Morris Goding
Access Consulting

Station Beach Boat House
Wharf Palm Beach

**Access Review –
DA 6**

PROPOSED FIRST FLOOR PLAN

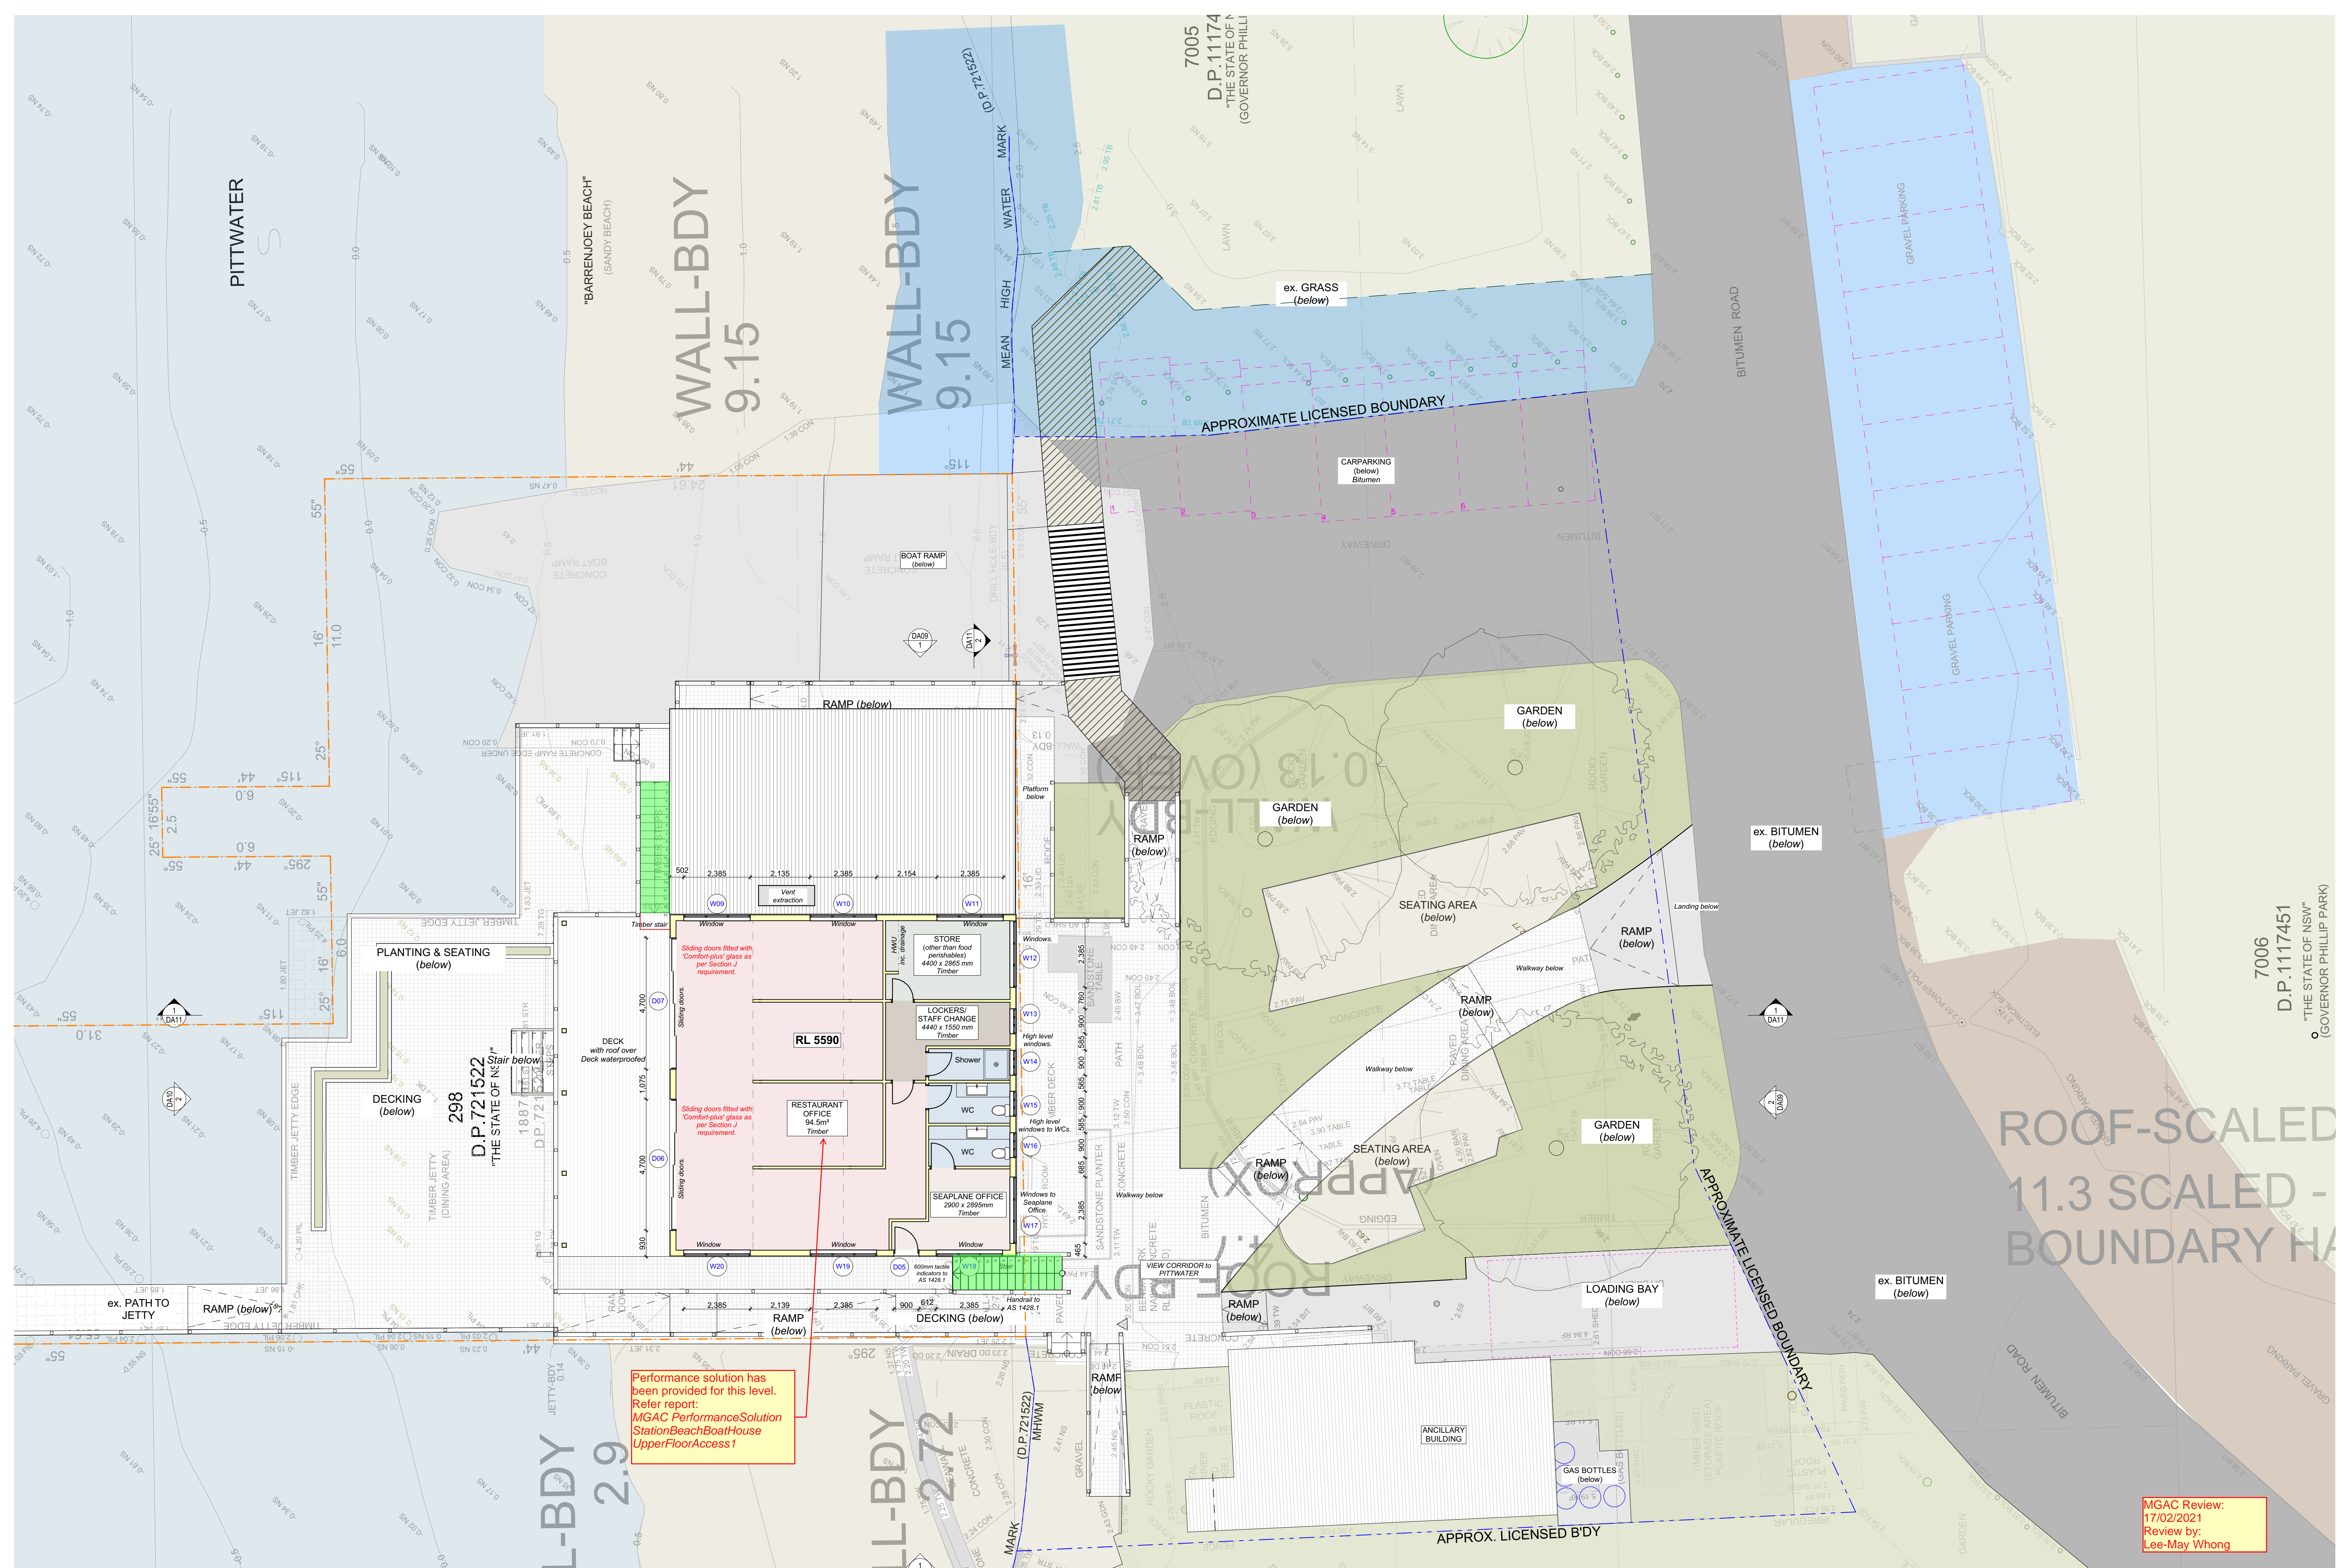
Performance solution has been provided for this level. Refer report: MGAC Performance Solution Station Beach Boat House Upper Floor Access 1
